BEAUMARIS CONCOURSE CAR PARK & STREETSCAPE WORKS BAYSIDE CITY COUNCIL LAYOUT PLAN- SHEET 1 of 2		SCALE @ A1	1:250	DRAWING No.:	18001 - 010	REV	4
FPA

**BEAUMARIS CONCOURSE**  
**CAR PARK & STREETSCAPE WORKS**  
 BAYSIDE CITY COUNCIL

**BEAUMARIS CONCOURSE**  
CAR PARK & STREETSCAPE WORKS  
BAYSIDE CITY COUNCIL  
PAVEMENT PLAN - SHEET 1 OF 2  
FLA  
DRAWN NO. 18001 - 200  
REV. 3

**BEAUMARIS CONCOURSE**  
CAR PARK & STREETSCAPE WORKS  
BAYSIDE CITY COUNCIL

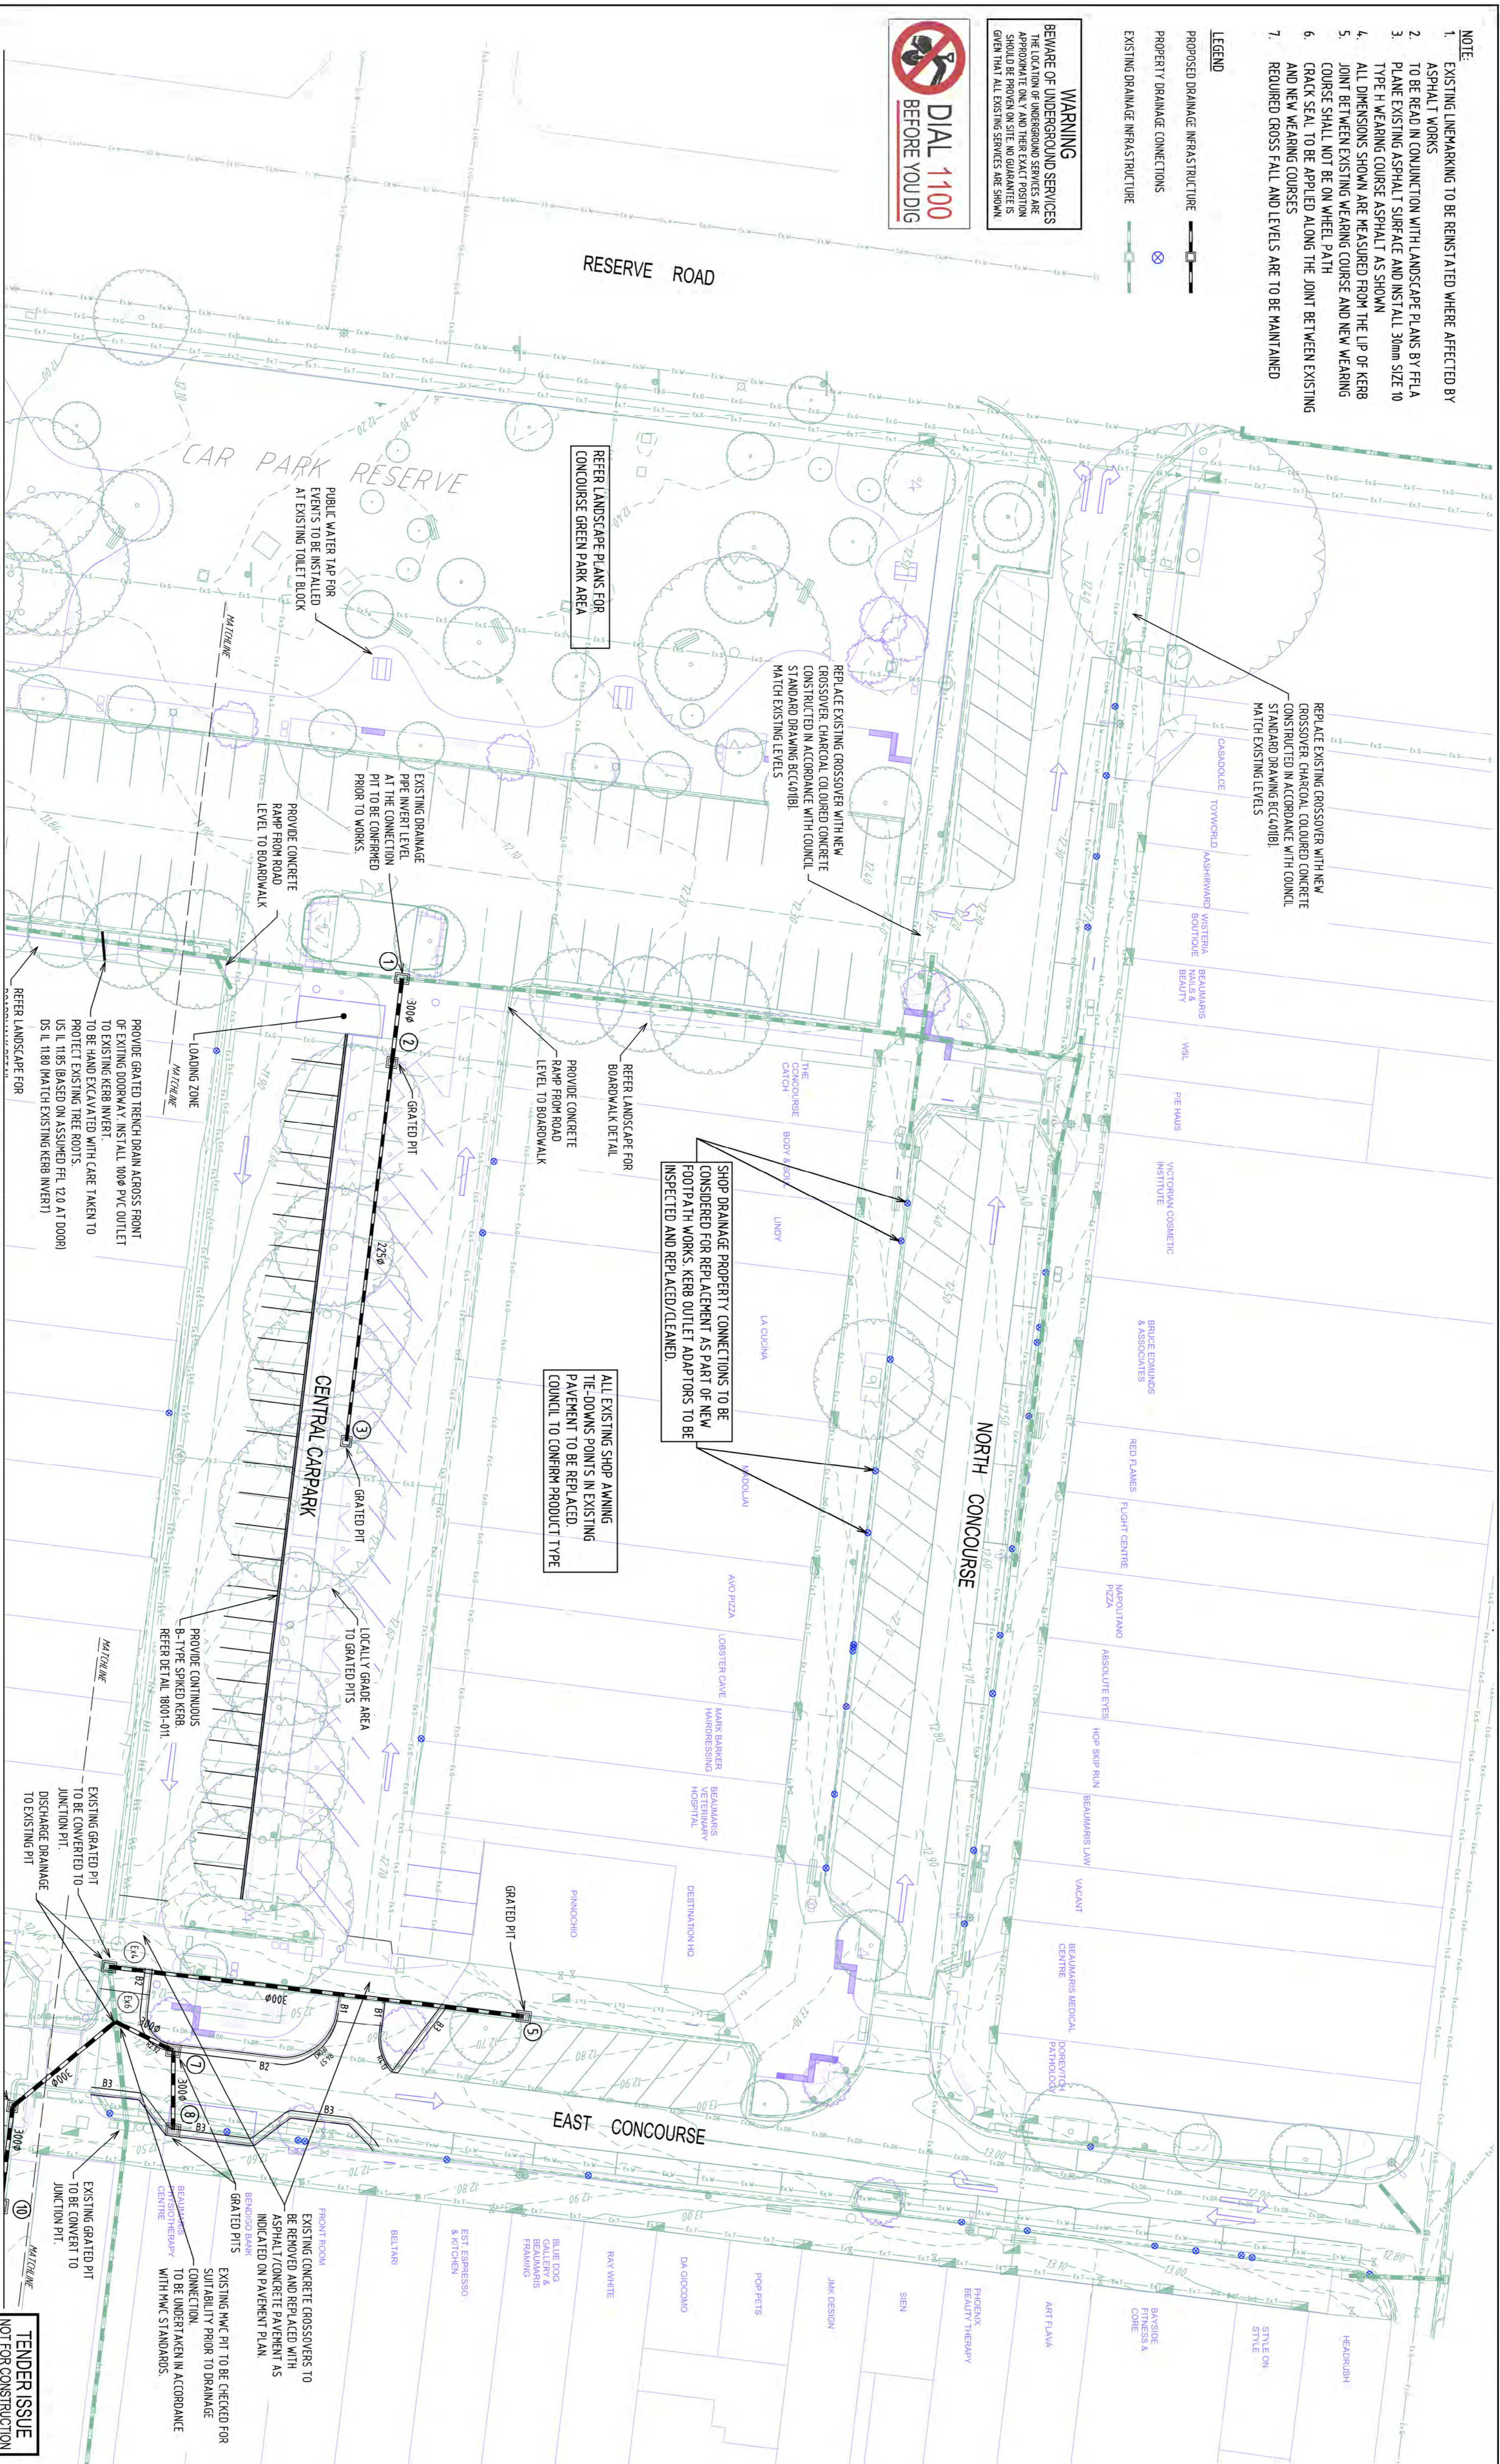
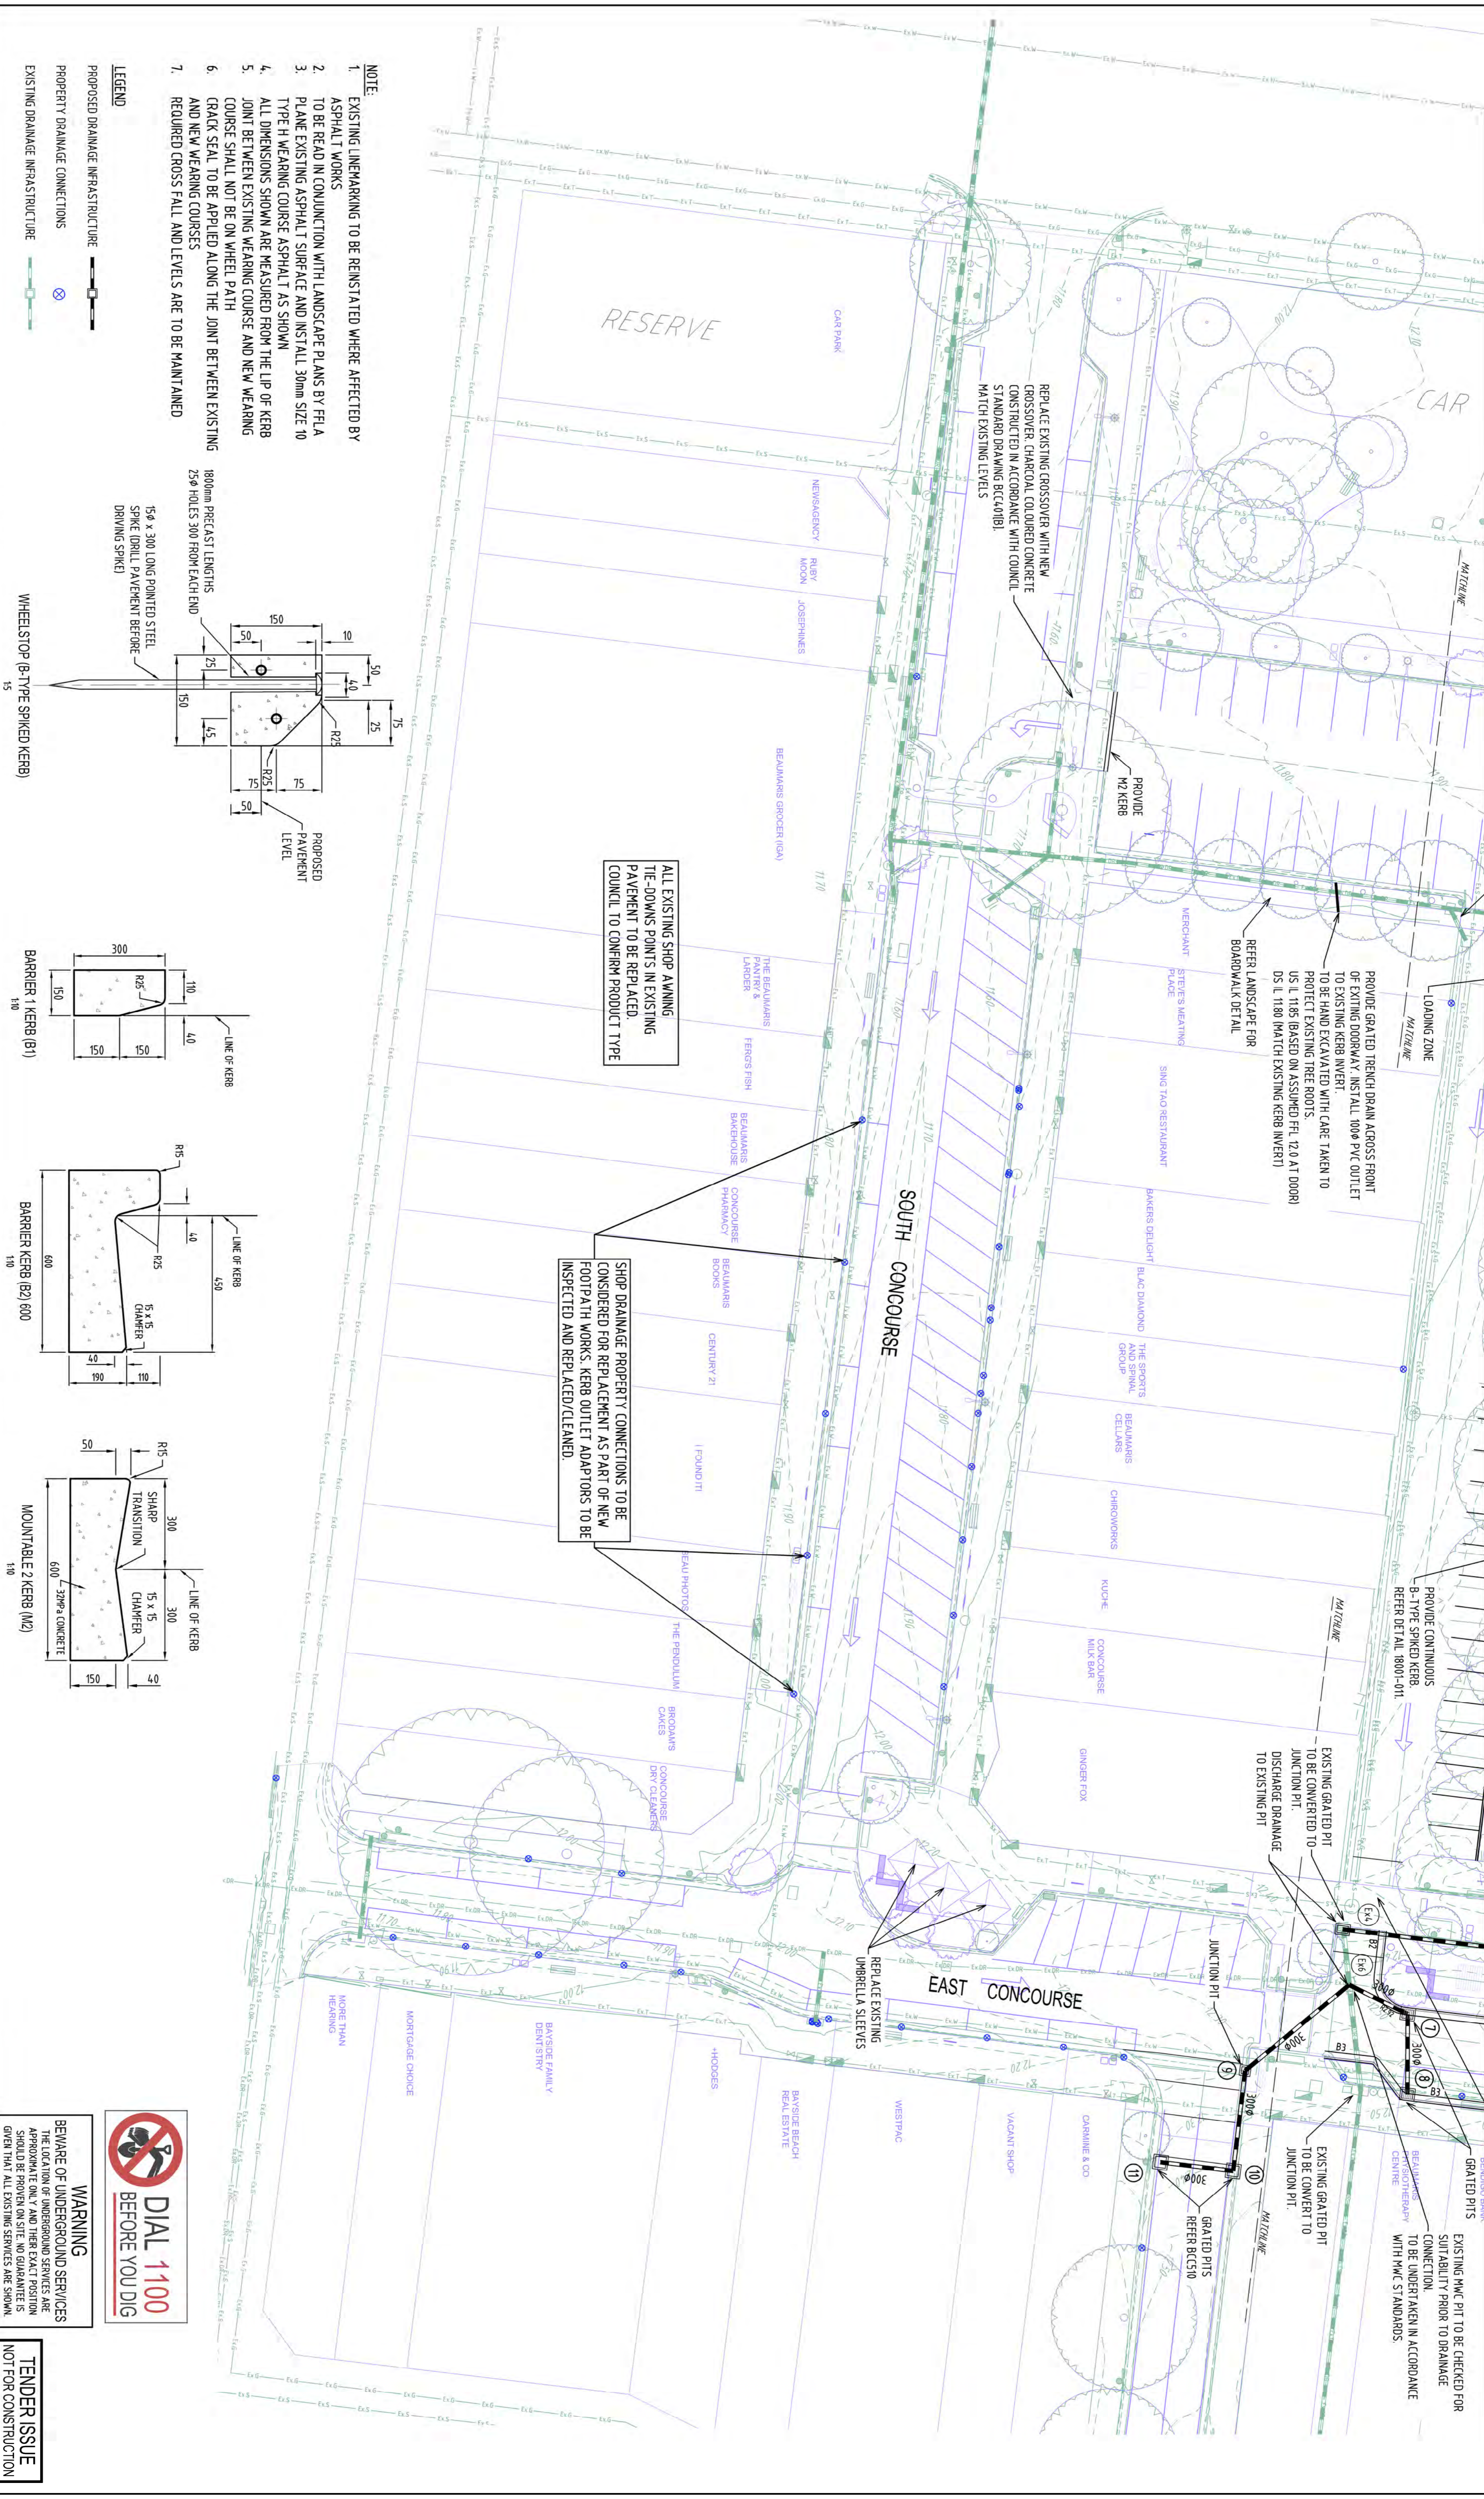
ROW	DESCRIPTION	CHECKED	APPROVED	DRAFTED	DATE
4	TENDER ADDENDUM - CONCRETE CROSSOVERS	JM	NP	MD	28.11.2018
3	ISSUED FOR TENDER - VZ	JM	NP	MD	21.11.2018
2	ISSUED FOR TENDER	JM	NP	MD	16.11.2018
1	PRELIMINARY ISSUE - NOT FOR CONSTRUCTION	JM	-	MD / VN	12.11.2018
0	PRELIMINARY ISSUE - NOT FOR CONSTRUCTION	JM	-	MD	18.10.2018

LAYOUT PLAN- SHEET 2 OF 2

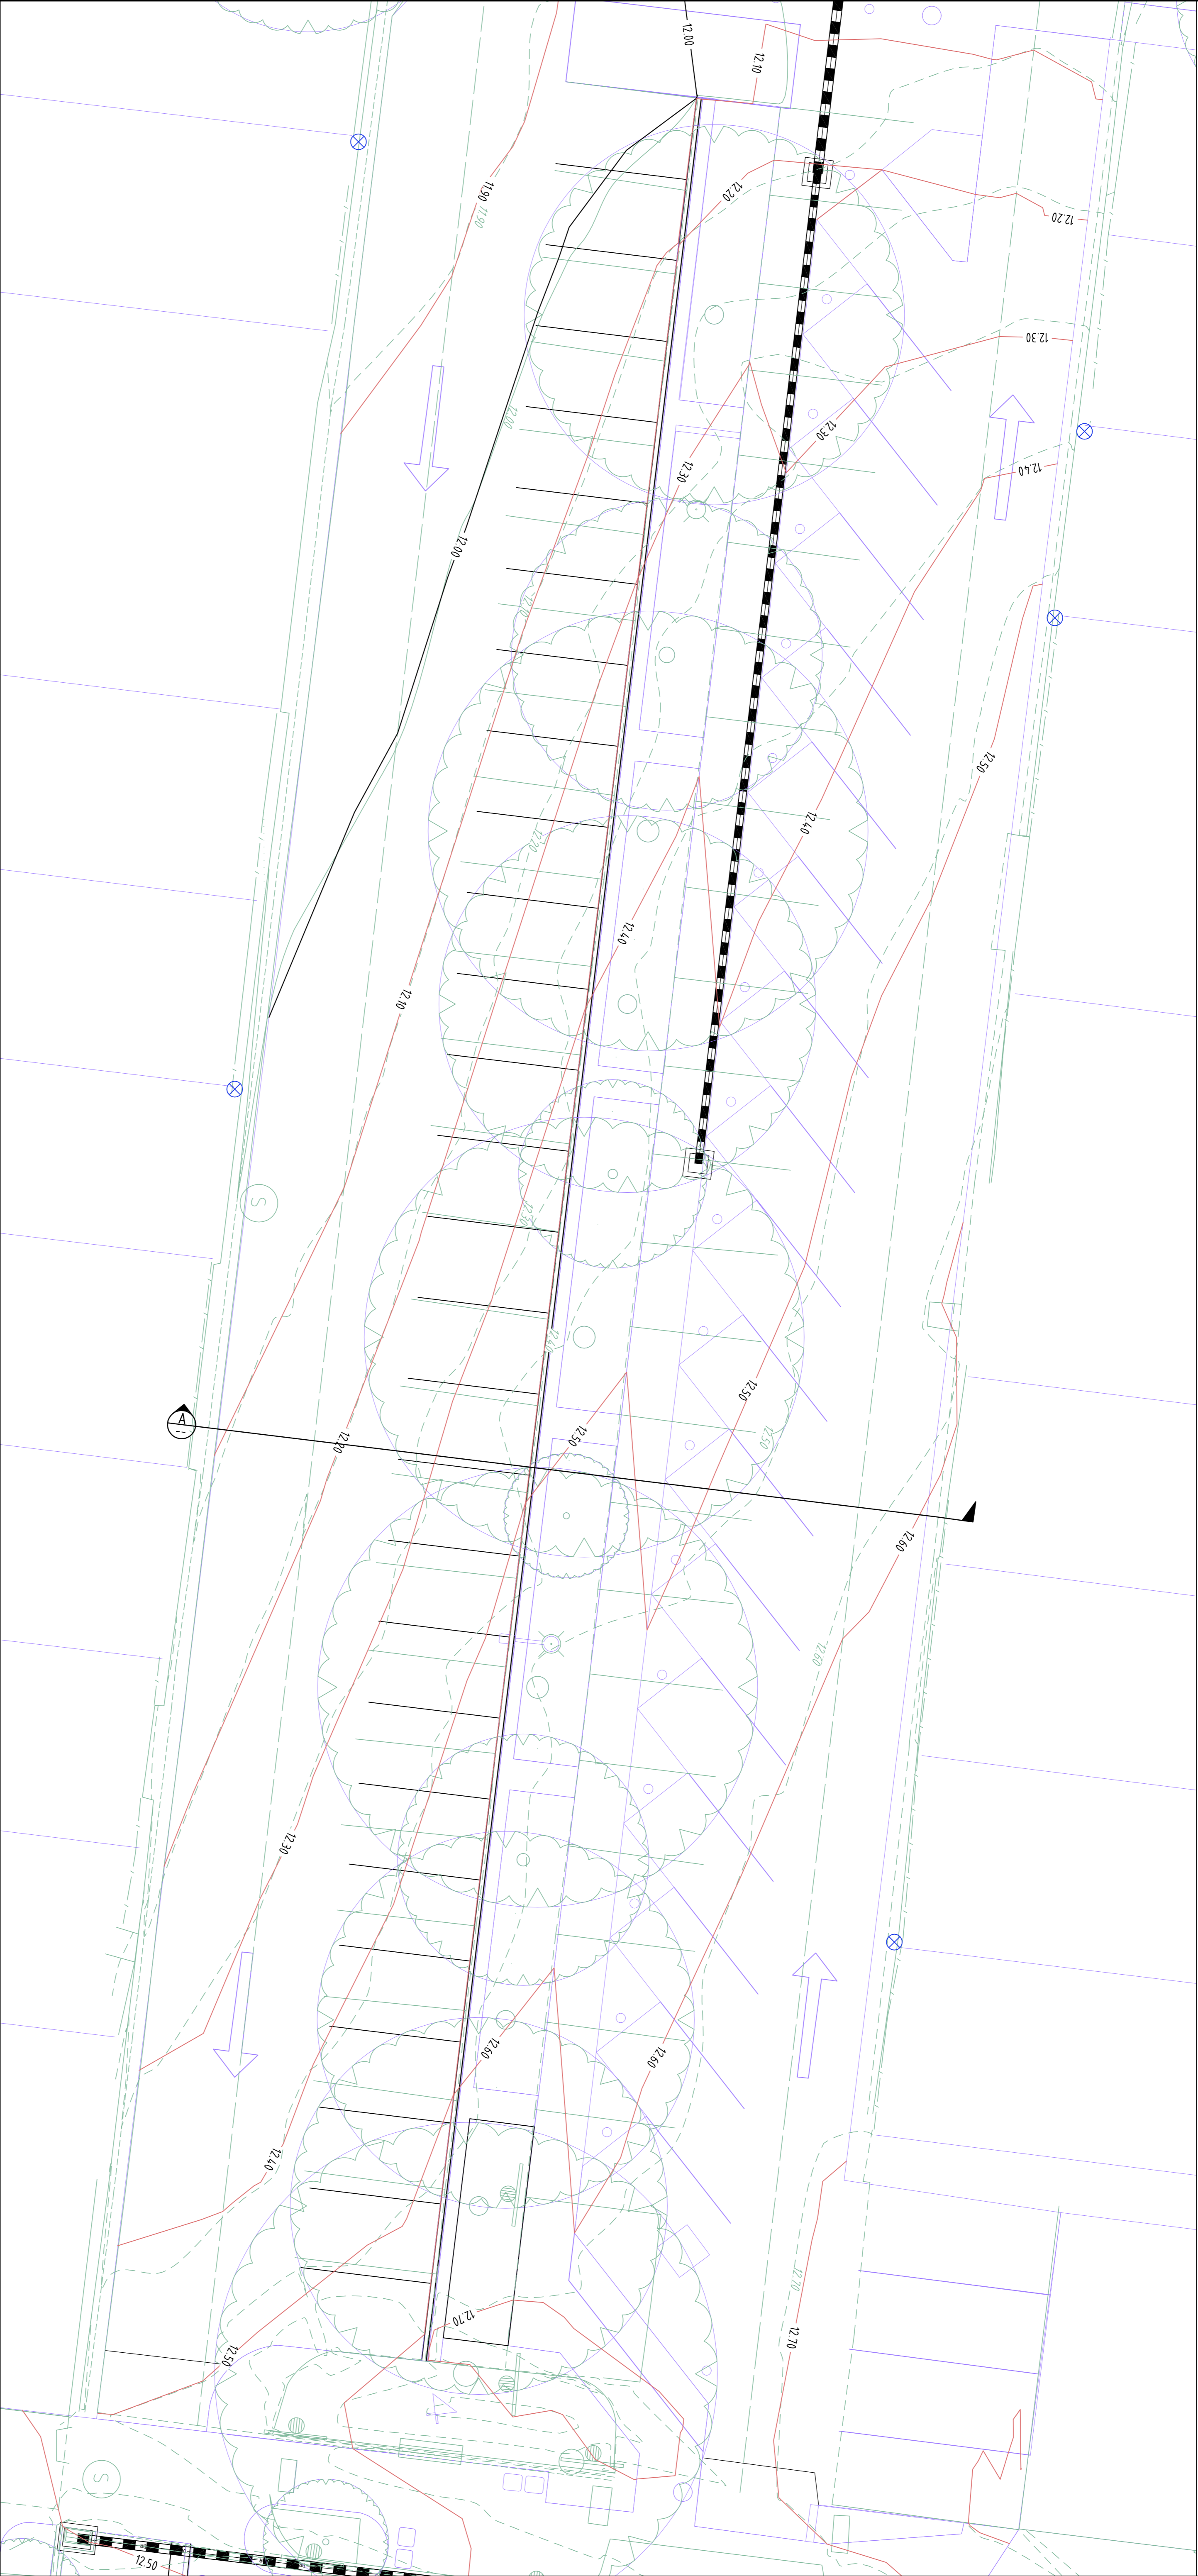
REV	DESCRIPTION	CHECKED	APPROVED	DRAWN/ETD	DATE
4	TENDER ADDENDUM - CONCRETE CROSSOVERS	JW	NKP	MD	28.11.2008
3	ISSUED FOR TENDER - V2	JW	NKP	MD	21.11.2008
2	ISSUED FOR TENDER - NOT FOR CONSTRUCTION	JW	NKP	MD	16.11.2008
1	PRELIMINARY ISSUE - NOT FOR CONSTRUCTION	JW	-	MD / VN	12.11.2008
0	PRELIMINARY ISSUE - NOT FOR CONSTRUCTION	JW	-	MD	18.10.2008
